AMENDMENTS TO THE DRAWINGS

Application No. 10/767,988
Amendment Dated
Reply to Office Action of October 13, 2005

FIG - 6

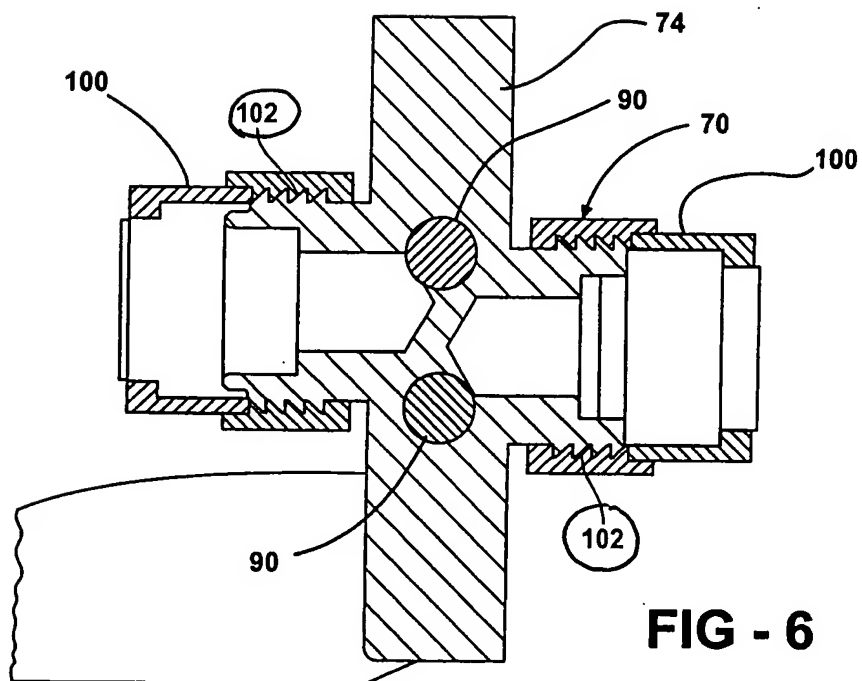
The drawings are also objected to because they do not depict the reference numbers "102" and "126". Appropriate correction has been made by inserting into Figure 6 the reference number 102, and by inserting into Figure 7 the reference number 126. Attached herewith are replacement sheets for Figures 6-8. Also attached are annotated sheets showing the changes to Figures 6 and 7 as described above.

Annotated Sheet Showing Changes to Figures 6 and 7.

FIG - 8

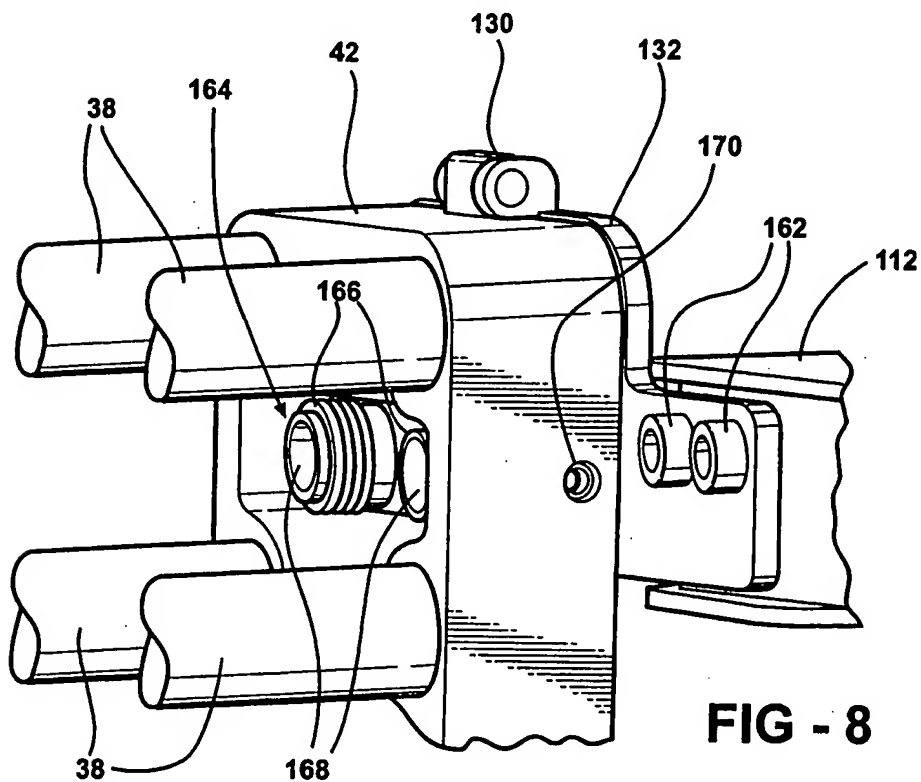
The drawings also are objected to because, in Figure 7, reference character 172 for the pyrotechnic device does not appear any different from what is described and shown in Figure 8

and represented with reference character 168. The Applicant respectfully submits that this is not a drawing issue. The difference between views depicted in Figures 7 and 8 is that reference character 172 refers to the pyrotechnic devices *per se*, which are placed into the chambers 168. The chambers 168 are shown empty in Figure 8. Thus, the pyrotechnic devices 172 are not depicted in Figure 8, as having been removed for clarity.
